V2500-A5 SERIES PROPULSION SYSTEM SERVICE BULLETIN

This document transmits Revision 1 to Service Bulletin V2500-ENG-71-0311

ENGINE – INSTALLATION OF CABLE WRAP ON THE ENGINE SYSTEM DRAIN PIPES (FOR CONTROLLED
SERVICE USE)(BANGKOK AIRWAYS ONLY)

Installation of the Spirap to the Drain Tube
Figure 1

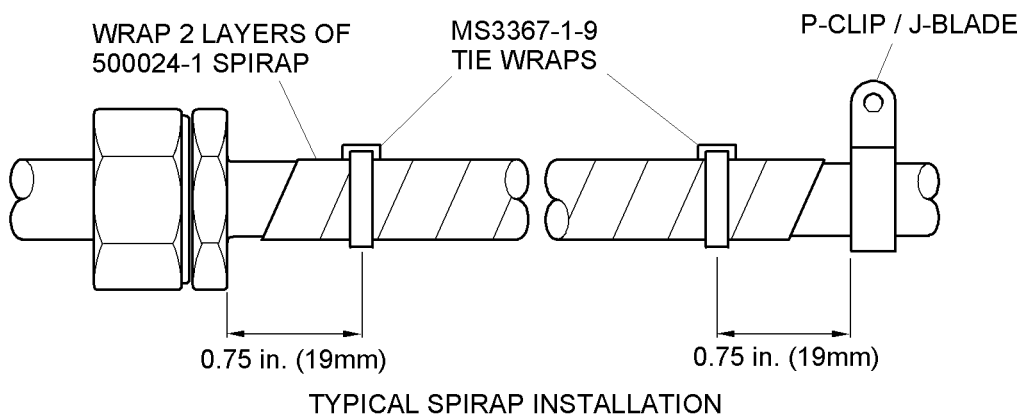
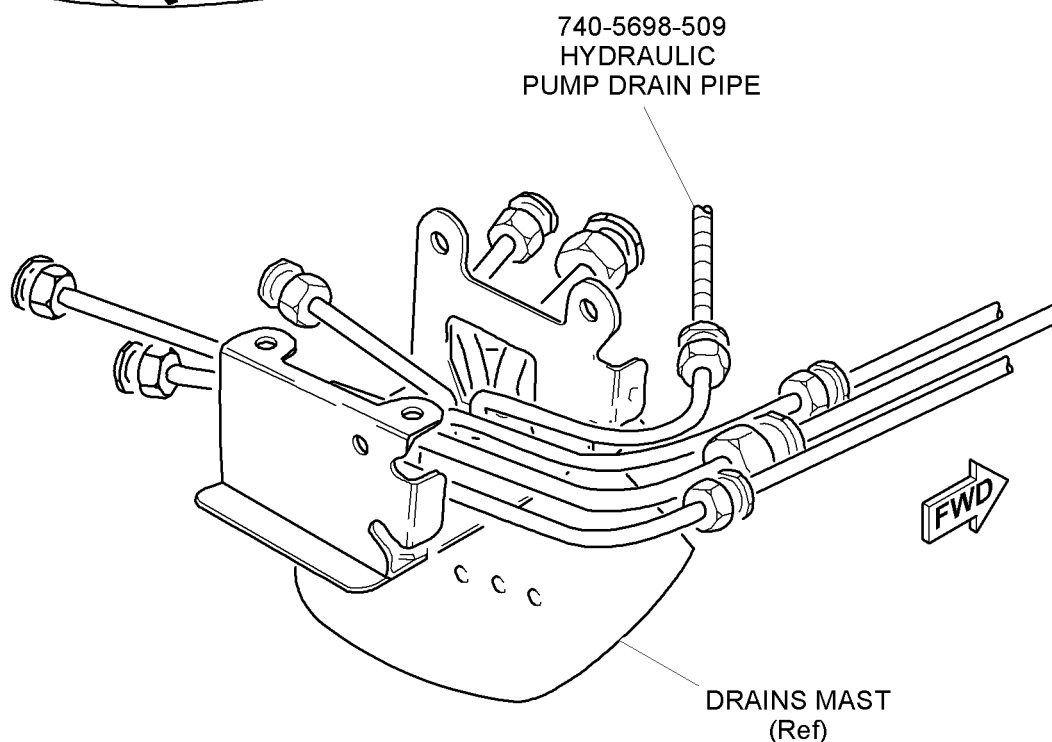
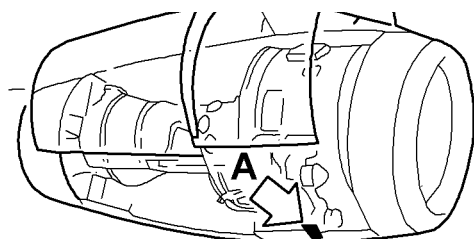
Some operators have experienced a hard foul between the #3 Latch on the Fan Cowl Door and the Hydraulic Pump Drains Line when the Door is being fully closed.

Airlines have experienced excessive wear of the Hydraulic Pump Drains Line in way of the #3 Latch on the Fan Cowl Door.

The hydraulic pipe is inspected and the findings recorded. The spirap is fitted to the hydraulic pipe and secured with tie wraps.

- (4) Use a clean lint free cloth (CoMat 02-099) made moist with solvent (CoMat 01-076 or CoMat 01-124) and remove dirt and grease from the surfaces of the drain pipes identified in Figure 1. Wipe the area dry before the solvent becomes dry.
- (5) Apply two layers of spirap, P/N 500024-1 around the pipe between the pipe union and the first clipping point.
- (6) Secure the spirap to the pipe with two tie wraps, P/N MS3367-1-9 fitted approximately 0.75in. (19,0 mm) from the Pipe Union and approximately 0.75in. (19,0 mm) from the first clipping point.
- (7) Close the Fan Cowl Doors as instructed in the A320/V2500-A1 A319/A320/A321/V2500-A5 Aircraft Maintenance Manual, Task 71-13-00-410-010.
